### Planning - Case Comments

**Project Number:** PR-2022-007999

**Project Name:** 1700 Unser Blvd. NW

**Request:** EPC final sign-off

**EXTERIOR ELEVATIONS**

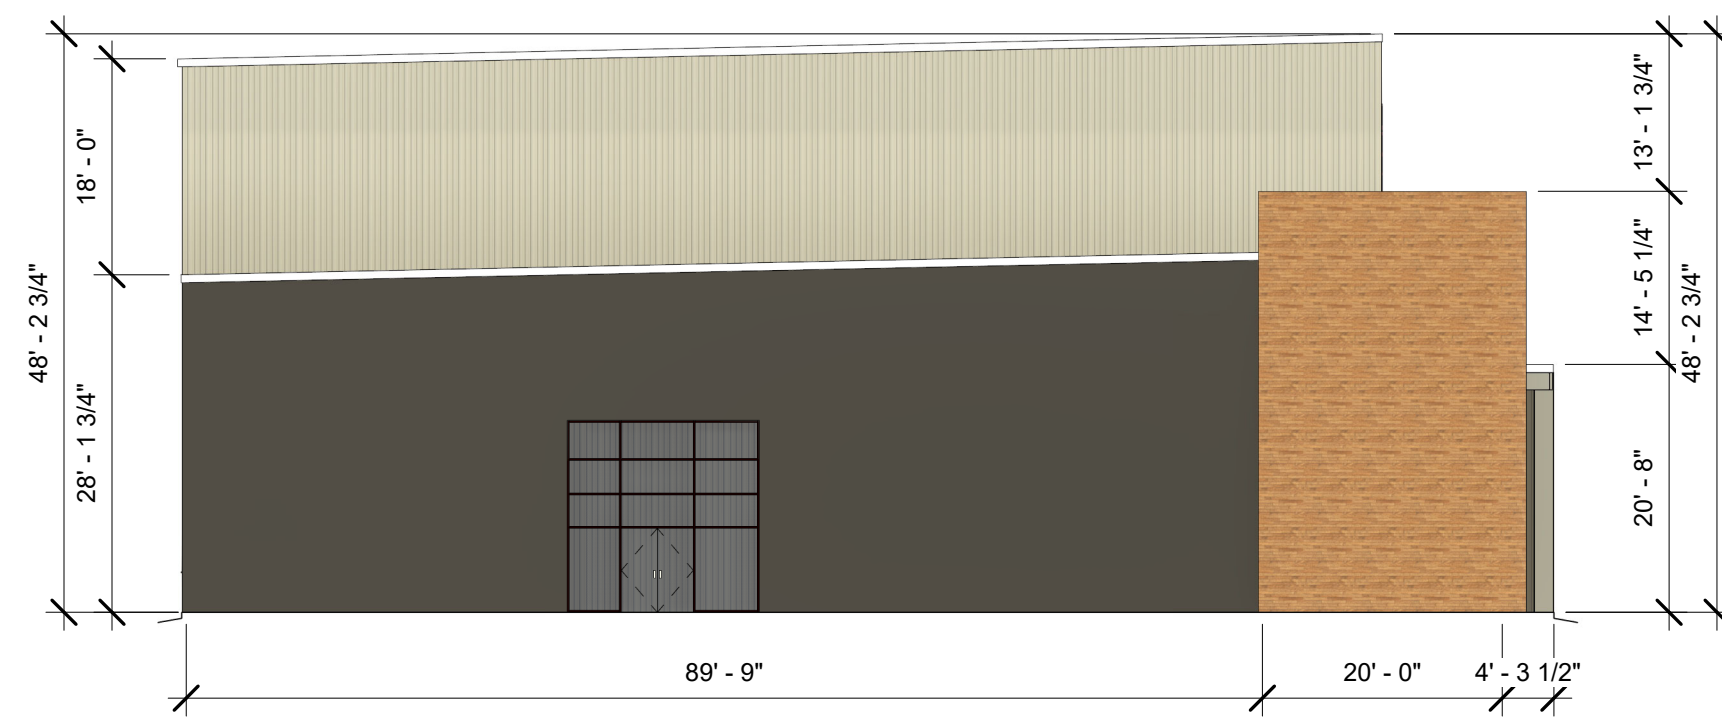
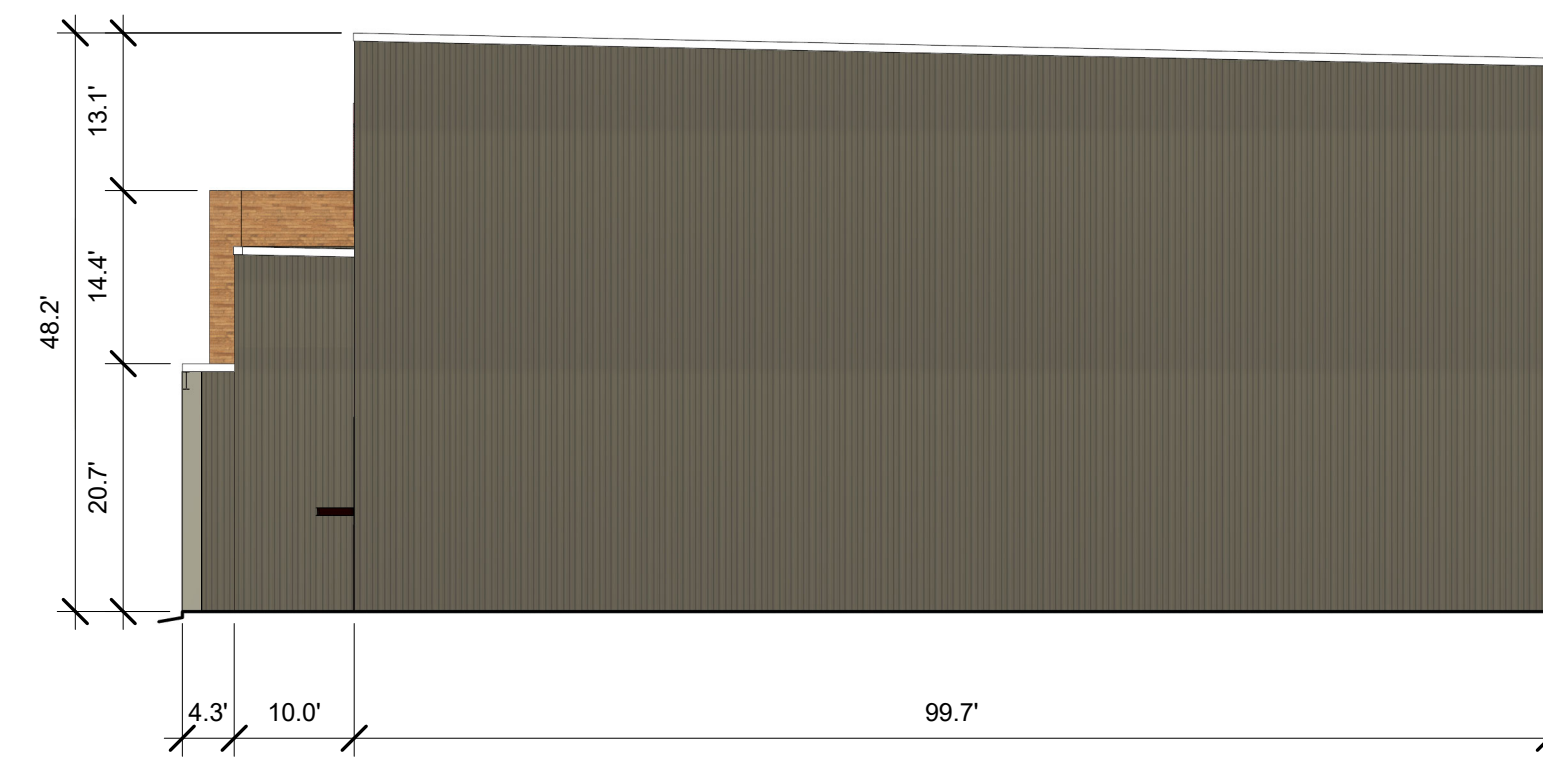
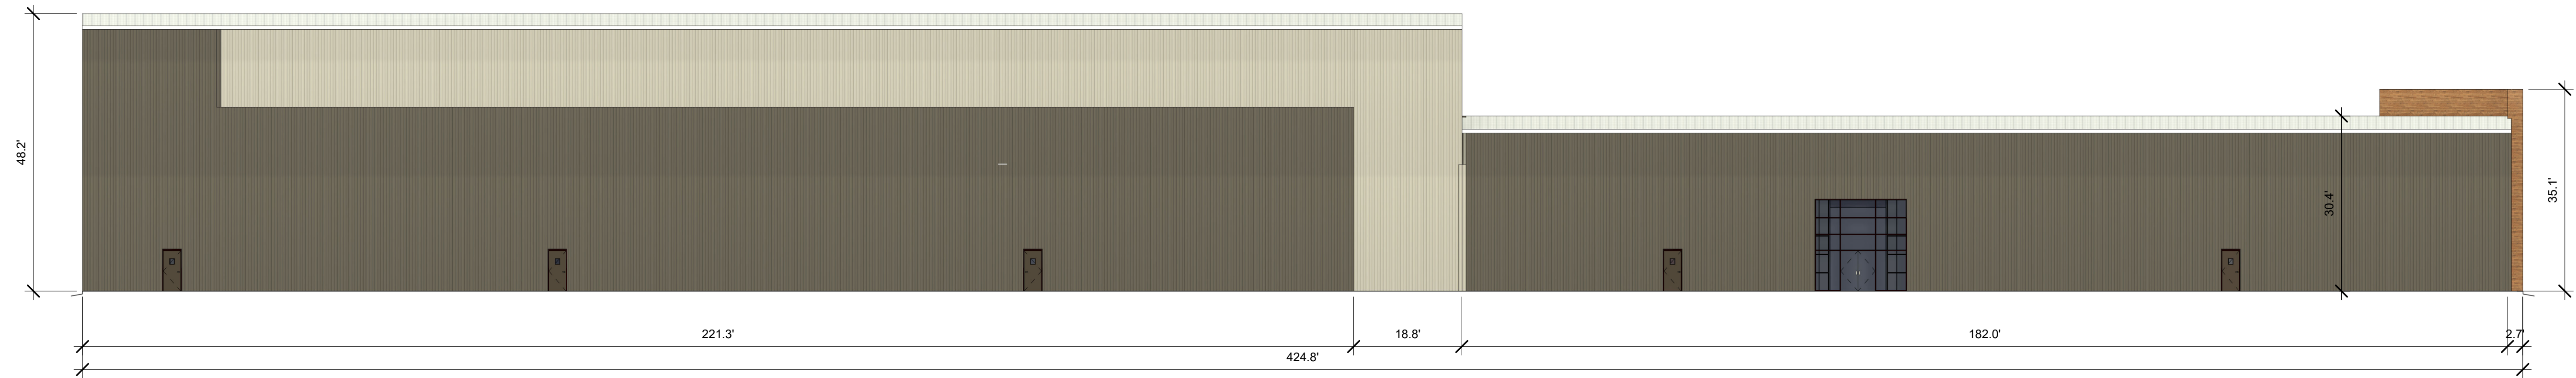
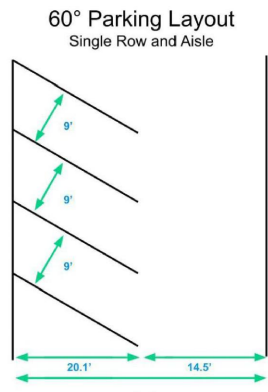
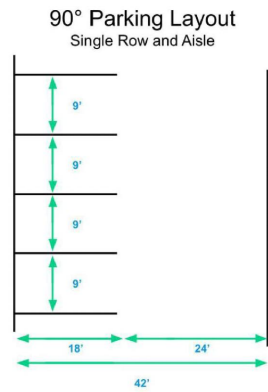
- Provide elevation sheets for the proposed warehouse-soundstage.

Provide Elevations of the proposed new structure with height/dimensions.

**ATTACHED**

Proposed new structure elevation/s attached. NOTE: Building height meets IDO limitations and APO requirements as noted on the EPC site plan.

SHEET NAME:  
TCL - DETAILS

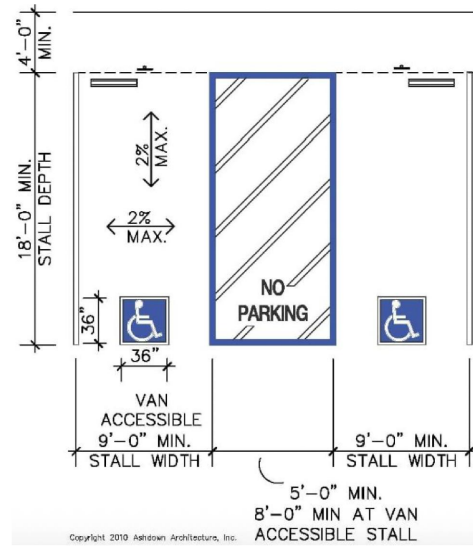
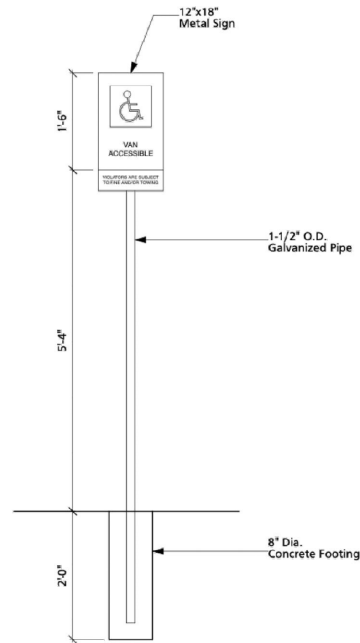
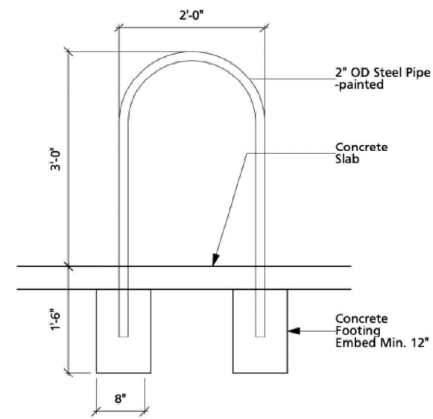
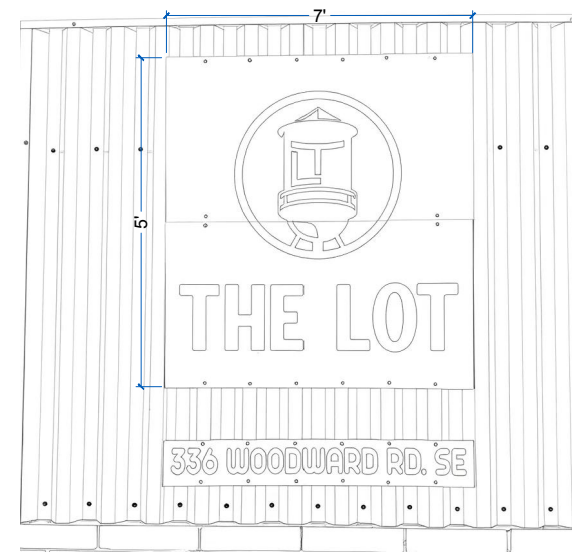
**Parking requirements: please clarify use classifications and provide parking requirement calculations for each use, accordingly, to show how the plan meets the required parking for the proposed use(s).**

Parking for the existing building, designated as Warehousing, has no requirement per Table 5-5-1 (excerpt below). 8 spots were provided, including all required handicap, motorcycle, and bike parking per the IDO. This is documented in the approved/attached 2003 TCL.

Parking requirements for the new building, designated as Light Manufacturing, have a requirement of 1 spot per 1000 sqft.

The new building is 44,000 sqft as shown on the approved EPC site plan, and 44 parking spaces are

provided for in the approved 2026 TCL. All other parking requirements, including standards, parking reductions, bike parking, handicap parking, lane access, lot slope, and parking island requirements, ect are all addressed in the approved/attached 2026 TCL.
